**Response to Request for  
Additional Information  
Southeast County Landfill (SCLF)  
Effluent/Leachate Storage Pond  
Pending Permit No.: #35435-005-SC,  
Hillsborough County**

Subject: Southeast County Landfill (SCLF) – Effluent/Leachate Storage Pond  
Pending Permit No.: #35435-005-SC, Hillsborough County

On behalf of the Hillsborough County Solid Waste Management Department (HCSWMD), SCS Engineers (SCS) submits the following responses to your letter dated February 2, 2001. For ease of review, the Florida Department of Environmental Protection (FDEP) comments from your letter are restated in bold, followed by our response.

Figure 1. Rainfall and Natural Evaporation at the Effluent Pond

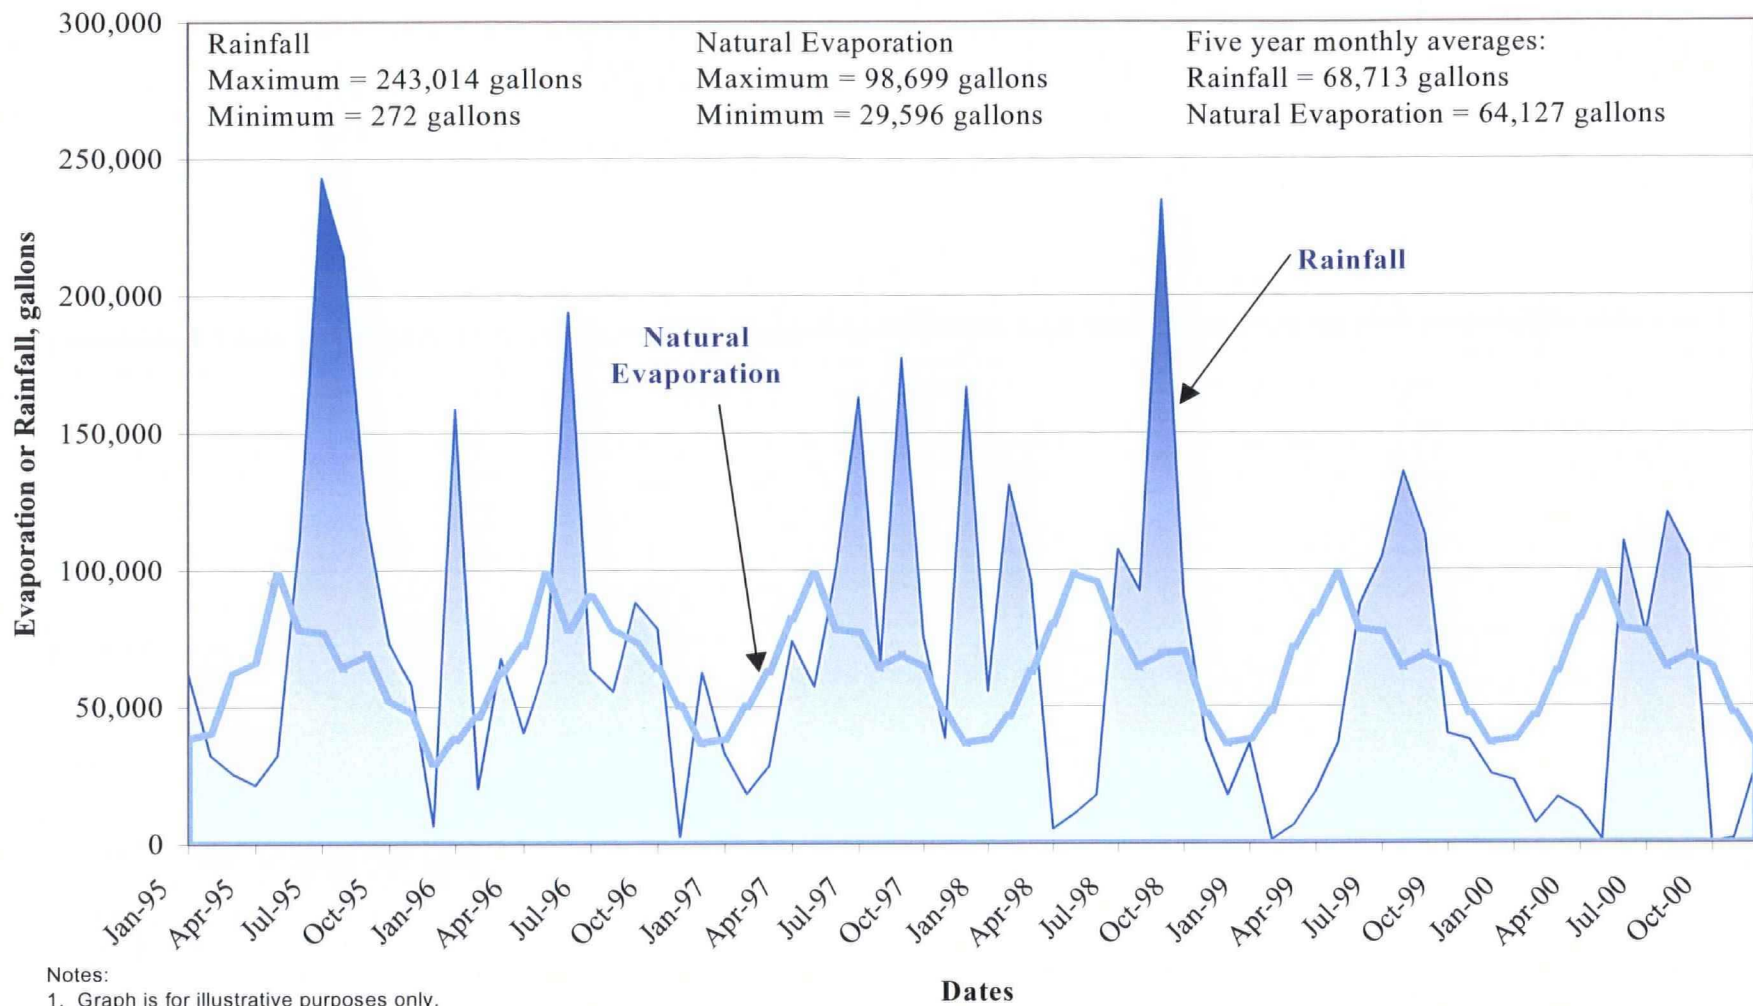
- (d) Rainfall and natural evaporation varies from month to month depending on weather conditions. In general, evaporation exceeds rainfall in winter and spring, and is less than rainfall in summer and fall, although there are exceptions. SCS simulated the water balance of the proposed pond using actual rainfall and evaporation data from 1995 to 2000. Figure No. 1 in Appendix A shows a plot of the volume of rainfall into and natural evaporation from the pond during this period. Figure No. 2 in Appendix A shows the performance of the pond with the addition of the spray evaporators. Figure 2 demonstrates that the pond equipped with the spray evaporators is capable of evaporating the rainfall incident to the pond plus significant quantities of effluent and/or leachate, as may be the case. Using the last 5-year rainfall data, the pond would have had an average of 69,000 gallons of rainfall per month, but be capable of evaporating 308,000 gallons per month (net disposed, and 239,000 gallons per month). The worst case condition during the 5-year period considered was July 1995. During that month, the maximum volume of water added to the pond from rainfall would have been 243,000 gallons. During that same period, the minimum natural evaporation would have been approximately 30,000 gallons. The net increase in storage in the pond would have been 213,000 without use of the spray evaporators. With the spray evaporators, approximately 264,000 gallons could have been evaporated, which would have resulted in a net effluent and/or leachate disposal 51,000 gallons.
